Coastal Access – Eastbourne to Camber length EBC2

Representations with Natural England’s comments

March 2022

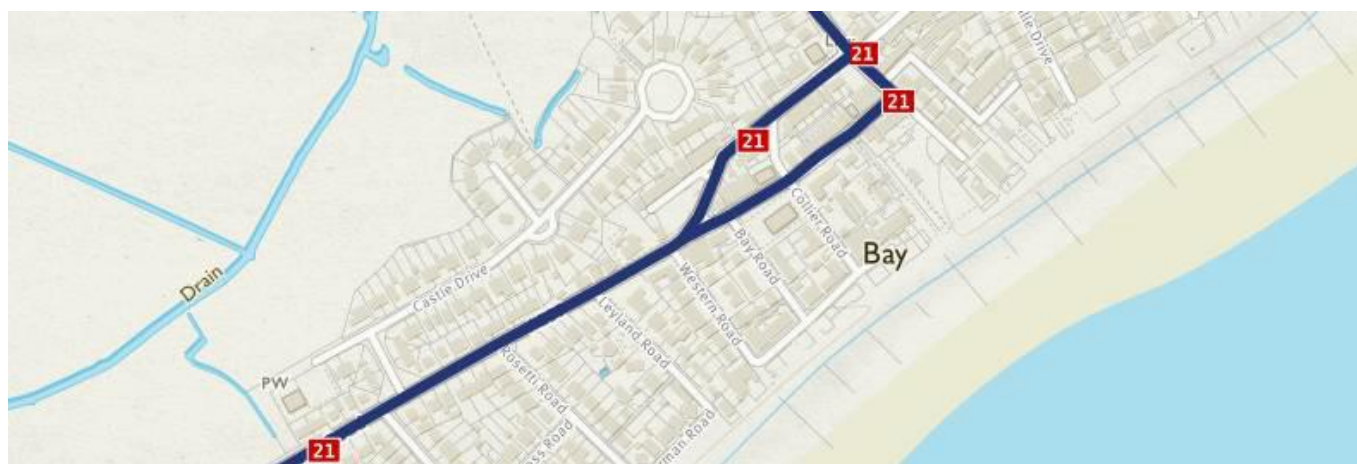
Bespoke Cycle Group are concerned that any improvements are not synchronised with Sustrans. The most dangerous section of the Sustrans Route 21 between Eastbourne and Cooden, is the one way traffic flow in Pevensey Bay on the A259. This route is also part of the Coastal Cultural Trail joining the 3 art galleries in Eastbourne Bexhill and Eastbourne. Bespoke suggests a cycle route from the A259 to the proposed trail between Norman Road (section EBC-2-S024) and Bay Avenue (section EBC-2-S054) – using surfacing across shingle area, should be a priority. Ideally this approach should be considered for other sections of the coast – such as Normans Bay to Cooden (Report EBC 3).

As explained in our comments on representations MCA/EBC Stretch/R/3/EBC2338 and MCA/EBC Stretch/R/1/ EBC2336, the England Coast Path project is principally aimed at those on foot, and while higher rights may exist along the trail, new higher rights would be dependent on landowners permission.

We work with groups and councils to share mixed use surfaces and routes, where it is appropriate and safe to do so, and it does not affect us achieving our aims. We consulted with Sustrans whilst we were developing the proposed trail route. We are aware that they were producing their own feasibility report for cycling between Pevensey Bay and Cooden and looking into cycling opportunities, particularly in areas where road cycling has been raised as a concern by cyclists and where the nature of the shingle foreshore makes coastal cycling difficult. Their investigations may lead to improved facilities for cyclists and we would be happy to discuss any ideas that link to the coast path. However we are not proposing to alter any of the existing grass or shingle surfaces currently found in this area.

Annex 2: Proposals for Optional Alternative Route and Coastal Margin around [redacted]’s ownership (hatched)

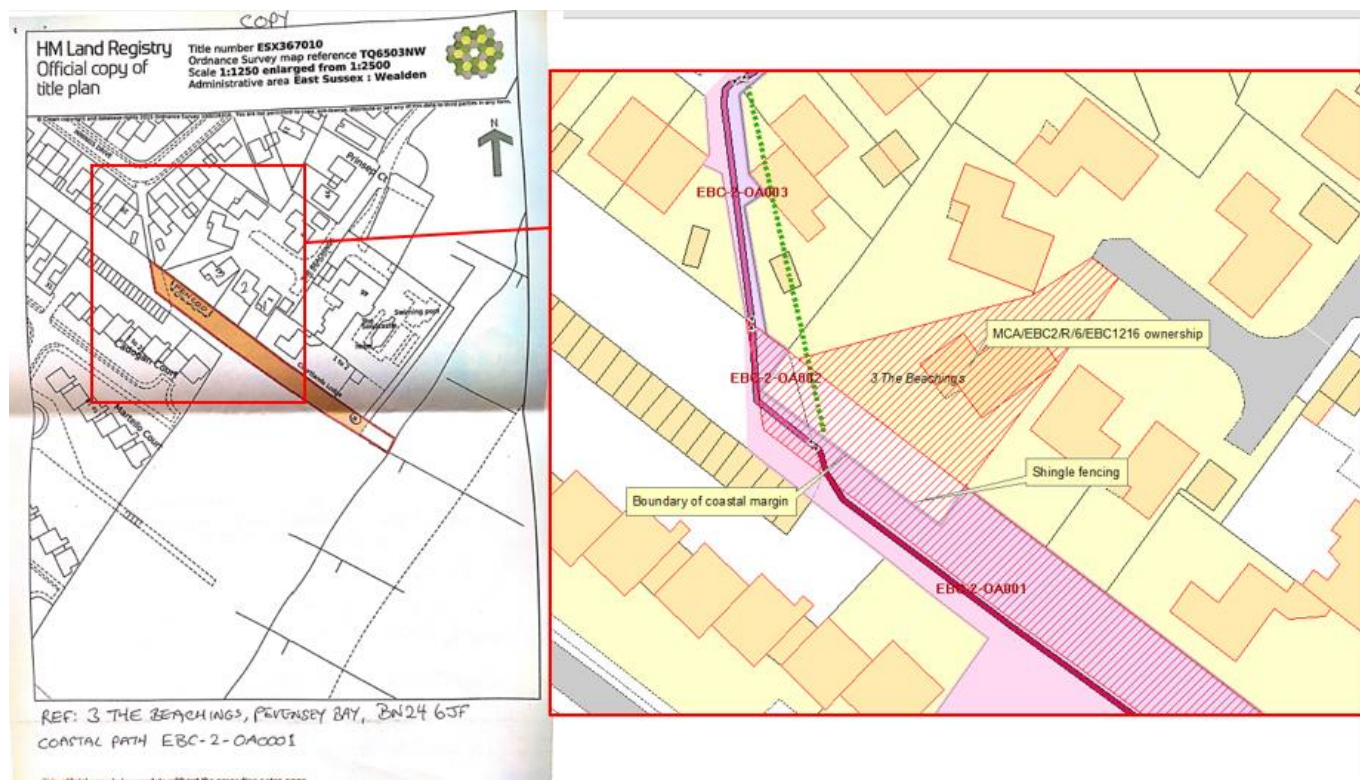
Summary of representation: EBC-2-OA001 is shown in notes under current status of route selection as 'Other existing walked route'. The land from the high tide line on the beach to the alleyway is privately owned. A section, approximately 2m wide, nearest to Cadogan Court, Grenville Road, is the only section not owned by [redacted], but is impassable due to a severe slope and overgrown scrub and brambles. Therefore, anyone using the optional route show at EBC-2-OA001 will be walking across her land.

An area immediately adjacent to [redacted] has been fenced. The land has mostly been left untouched to allow residents of Innings Drive to walk through the beach. This was discussed during consultation and whilst willing for this land to be used as an optional alternative route she wishes for the notes to reflect that the land is privately owned, as opposed to 'other existing walked route'.

With regards to the signage, as discussed during the initial consultation, placing signs showing an alternative route will indicate a path that is currently only known by local residents, Whist she appreciates the need for an alternative route when a very high tide makes the beach line impassable, using signs to indicate a path is also likely to attract walker from the existing caravan sites that are west of this location, including the large holiday camp at Pevensey Bay Holiday Park, who are walking to the village and do not wish to do so on the beach. This would significantly increase the footfall beyond those specifically walking the coast path. She wishes to consult about signage, with preference for not having any, but if required, for the wording to include reference to the land being privately owned so that those using it do so in a respectful manner.

Our proposals do not routinely include details about land ownership along the trail. However, issues relating to the interests of landowners are considered during the development of the trail, as Section 297 of the 2009 Act requires us in discharging the coastal access duty to aim to strike a fair balance between the occupier's interests and the public's interest in having access rights over land.

After discussion with [redacted], we aligned the proposed Optional Alternative Route away from both her garden fence and the fencing she erected on the shingle. Our proposals, in Tables 2.3.1 and 2.3.2, also specify that the landward boundary of the coastal margin for route section EBC-2-S019 extends only to her fencing, which marks the top of the beach: a default coastal land type. Our detailed proposals for this area of coastal margin are shown in Annex 2 – Proposals for Optional Alternative Route and Coastal Margin).

The status of ‘other existing walked route’ assigned to section EBC-2-OA001 indicates that this route is currently walked (most likely by local people) and does not have any bearing on the ownership status of the land.

We are aware of [redacted]’s desire for minimal signage of the optional alternative route. However, waymarking is necessary to ensure that when visitors cannot continue along the beach seaward of sections EBC-2-S019 to EBC-2-S021, during particularly high tides, it is clear where the diversion goes. During the establishment of the trail infrastructure, we will share details of the proposed signage with [redacted].

We do not have evidence that pedestrian access along such a route would cause anti-social behaviour as walkers are also likely to continue to respect the residential nature of the area. However, there is nothing in the MCA 2009 legislation that would prevent [redacted] from erecting signs to remind visitors to walk through the area in a respectful manner.
